UNITED STATES PATENT AND TRADEMARK OFFICE

APPLICATION NO.	FILING DATE	FIRST NAMED INVENTOR	ATTORNEY DOCKET NO.	CONFIRMATION NO.
10/597,995	07/02/2007	Fred Van Essen	031707/315410	8930
826 7590 01/23/2009 ALSTON & BIRD LLP BANK OF AMERICA PLAZA 101 SOUTH TRYON STREET, SUITE 4000 CHARLOTTE, NC 28280-4000			EXAMINER YUSUF, MOHAMMAD I	
			ART UNIT	PAPER NUMBER
			4177	
			MAIL DATE	DELIVERY MODE
			01/23/2009	PAPER

Office Action Summary

DETAILED ACTION

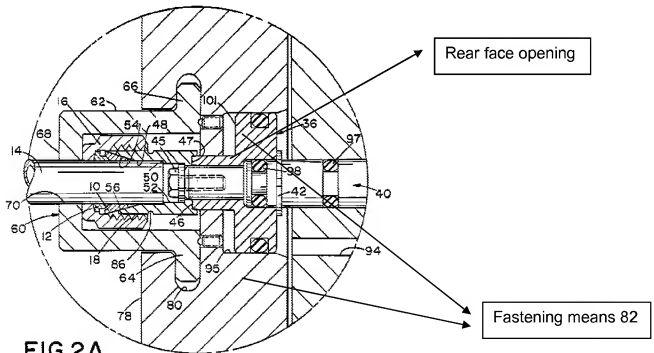
A head assembly (Fig. 2A) for a swage press (see title, "Swaging tool ...") including a housing (Fig. 2A, retaining cap 60) having a peripheral side wall (annular body portion 62), a front wall (second end 68) integrally formed with said peripheral side wall with an opening (aperture 70) in said front wall providing access to a press zone (press zone includes 16, 56, 45 etc in side the peripheral side wall or annular body portion 62) arranged within said peripheral side wall, said housing having an open rear face (shown on the attached Fig. 2A below);
a rear wall (78) secured by fastening means (fastening means 82) to said peripheral side wall (62) to at least partially close said rear face of the housing,
and a hydraulically operated (Fig. 2, hydraulic pump 90; also see column 6, lines 40-45) press mechanism (anvil 44) located within said housing (retaining cap 60) at least partially surrounding said press zone.

i) a housing (retaining cap 60) having a peripheral side wall (annular body portion 62), a front wall (second end 68) integrally formed with said peripheral side wall with an opening (aperture 70) providing access to a press zone (press zone includes 16, 56, 45 etc in side the peripheral side wall or annular body portion 62) arranged within said peripheral side wall, said housing having an open rear face (shown on the attached Fig. 2A below);

Johnston uses, (Fig. 2A, see attached figure above in paragraph 3), a sideways fastening means 82 instead of groove and wire mechanism as claimed However,
